UNITED STATES PATENT AND TRADEMARK OFFICE

APPLICATION NO.	FILING DATE	FIRST NAMED INVENTOR	ATTORNEY DOCKET NO.	CONFIRMATION NO.
10/088,539	03/19/2002	Veikko Kankaanpaa	540-016.2	6927

DETAILED ACTION

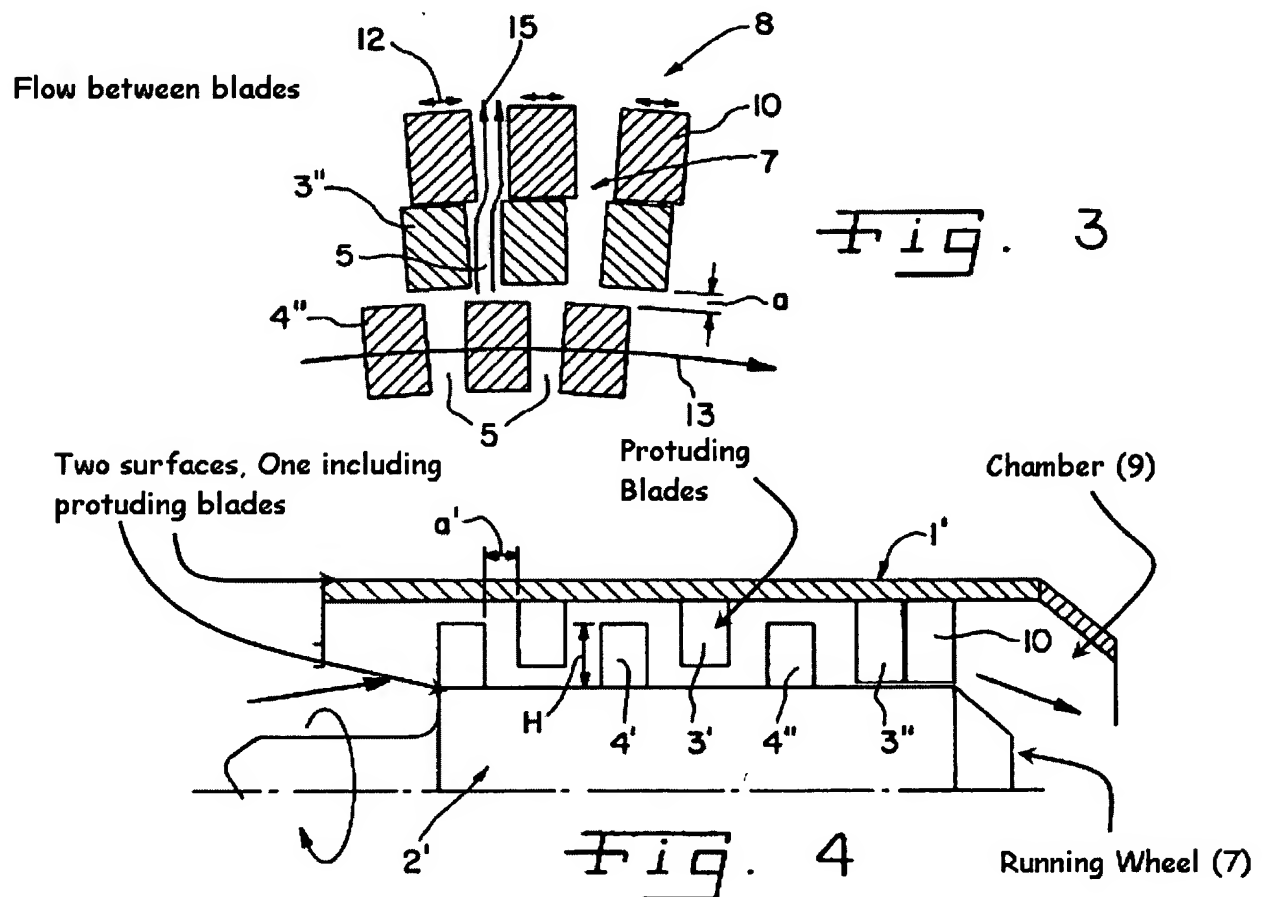
Schneid et al. teach a method of dispersing pulp containing solid material and a liquid phase in a dispersing device (Figures 1, 4) wherein the dispersing takes place in a narrow opening (a) between rotating protruding blades having conical surfaces (3 3', 3'') and (4, 4' 4'') on the rotor (2) and stator (1). Figure 4 shows a running wheel, which would rotate the blades and acts as a pump to pump the dispersed material out of the dispersing device, see below.

Note that the running wheel protrudes within the outlet chamber; see figures above.
